GENESEE COUNTY PLANNING BOARD REFERRALS NOTICE OF FINAL ACTION

T-02-BER-04-24

Site Plan Review for a new freight storage and maintenance facility.

**RE: TOWN OF BERGEN – DMT FREIGHT, INC.
SITE PLAN REVIEW
MRB GROUP PROJECT NO. 0202.24000.006**

SITE PLAN

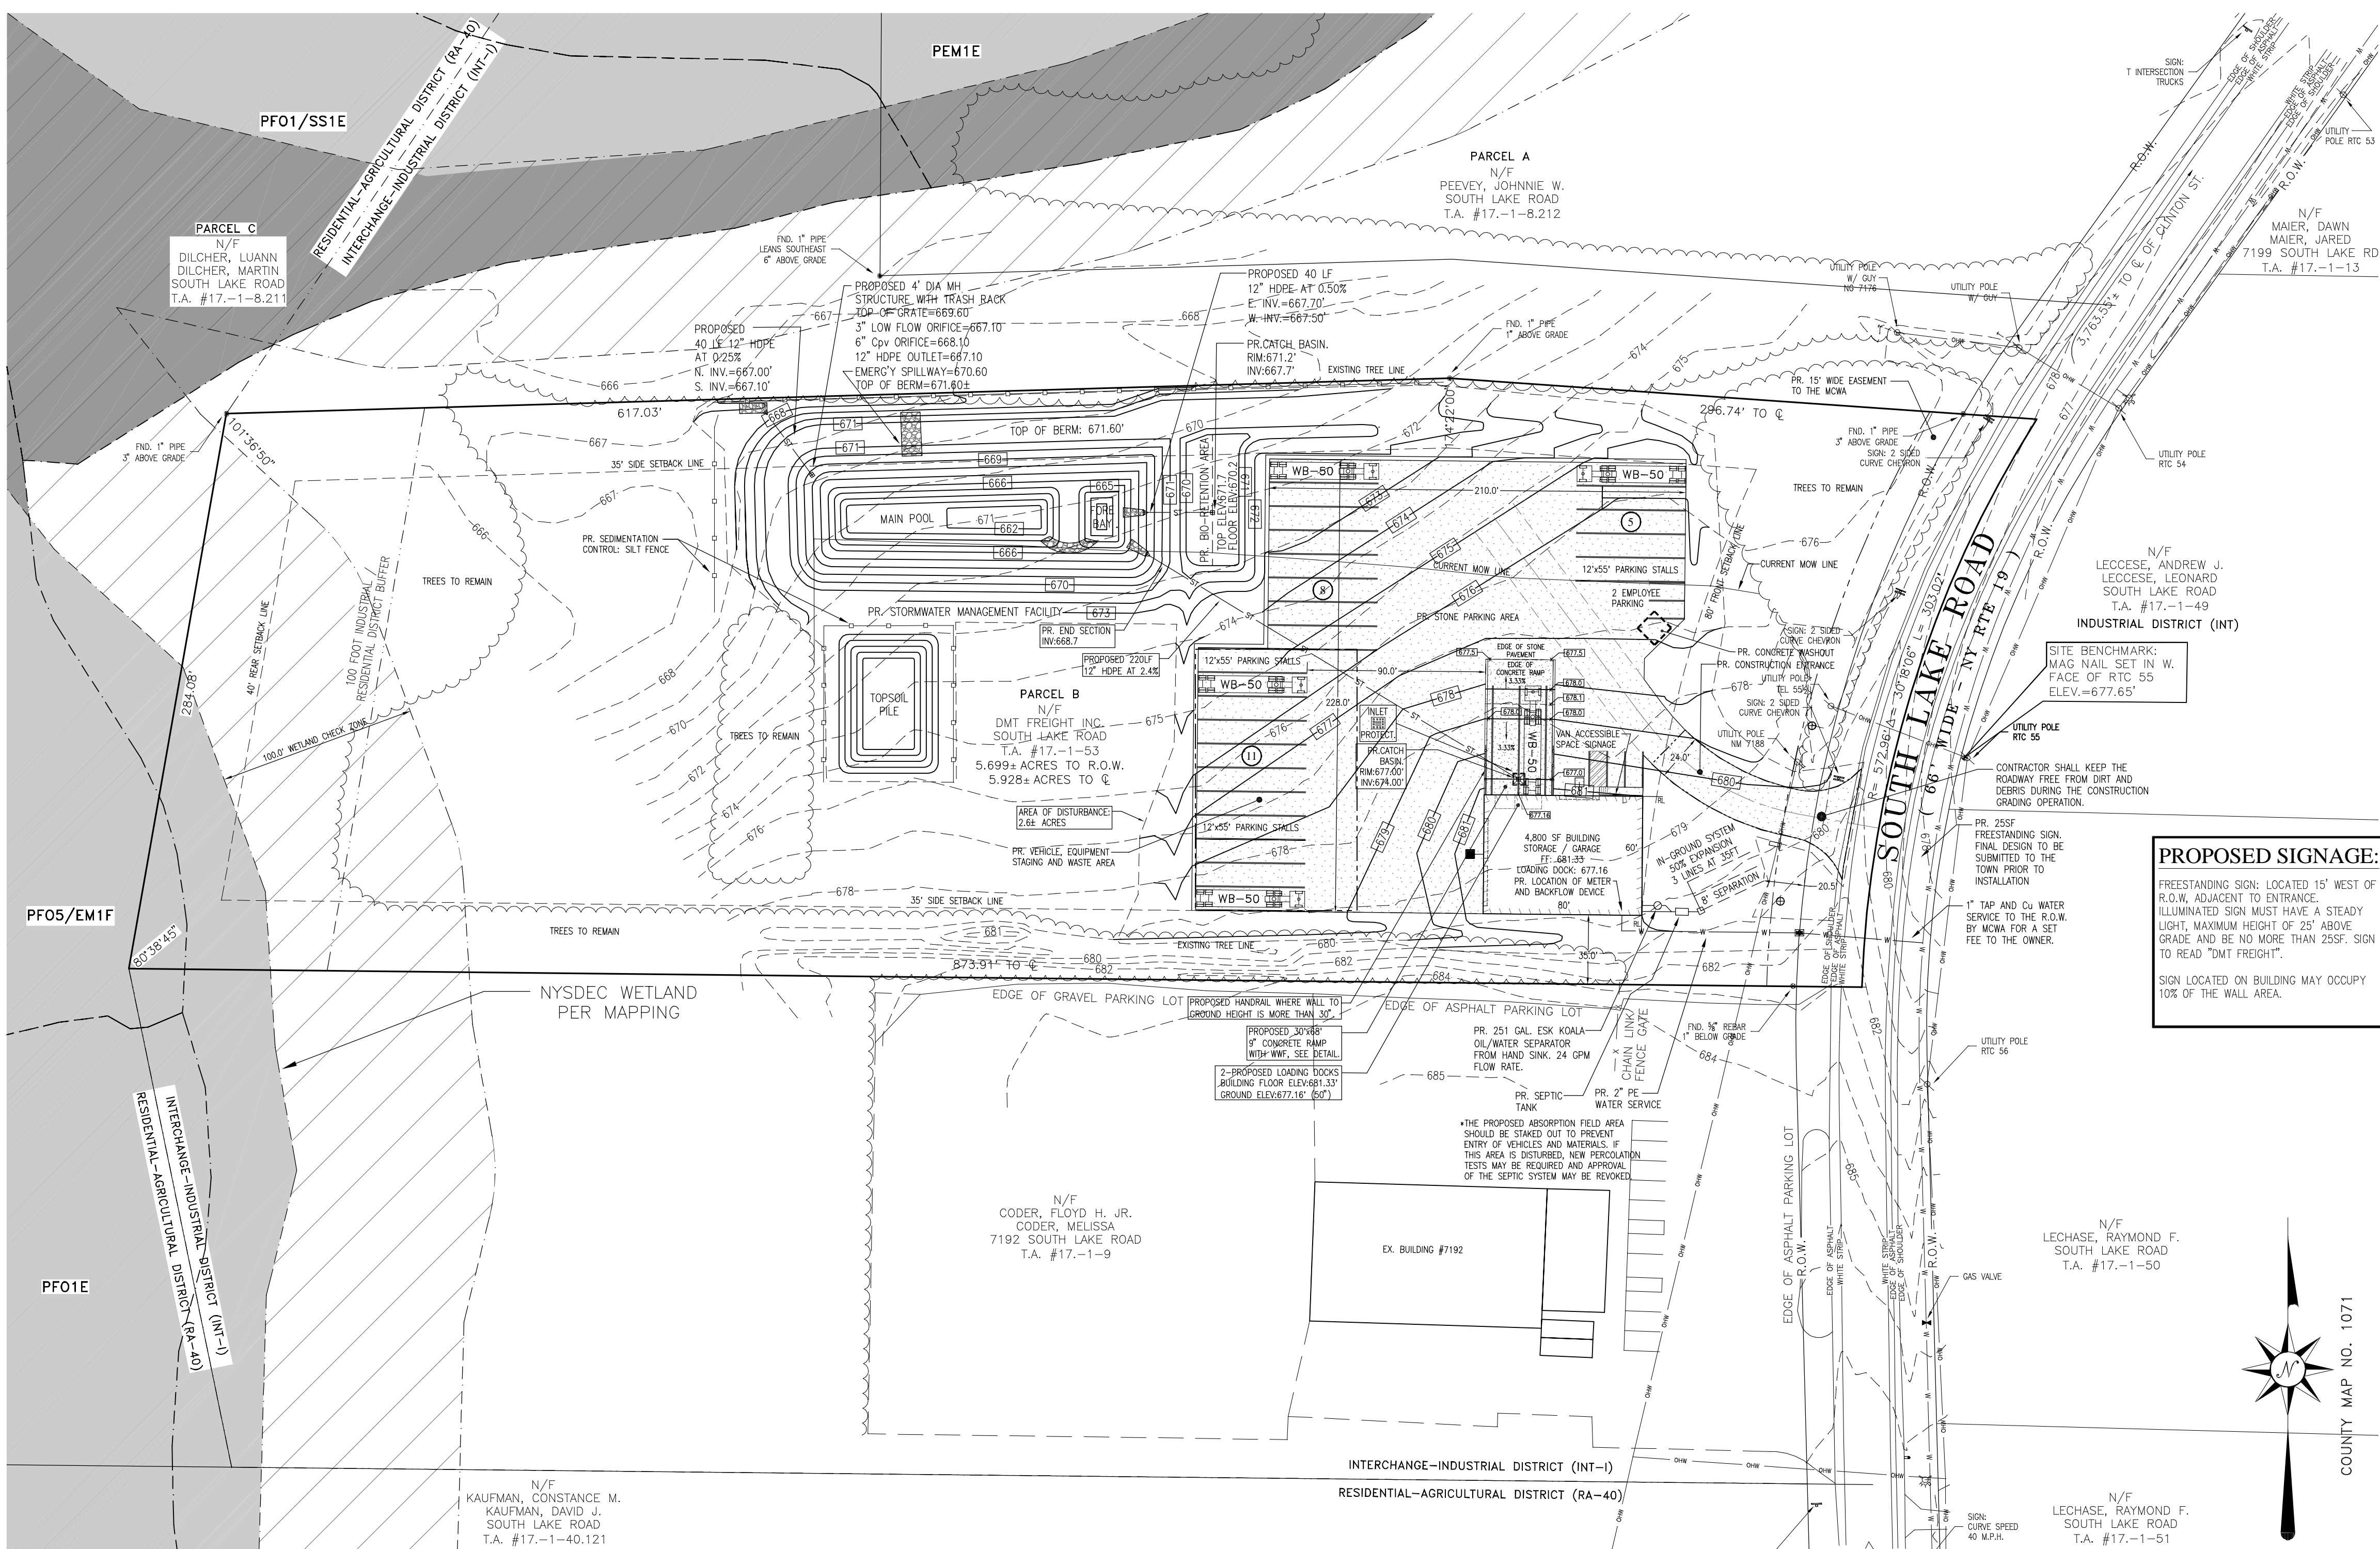
8. Sheet C-1 shows 2" water service with a 1" tap. Please Clarify.
9. Site distances for the proposed driveway should be added to the plans.
10. The soil stockpile should be shown on the plans. Details should be added to sheet C-3.
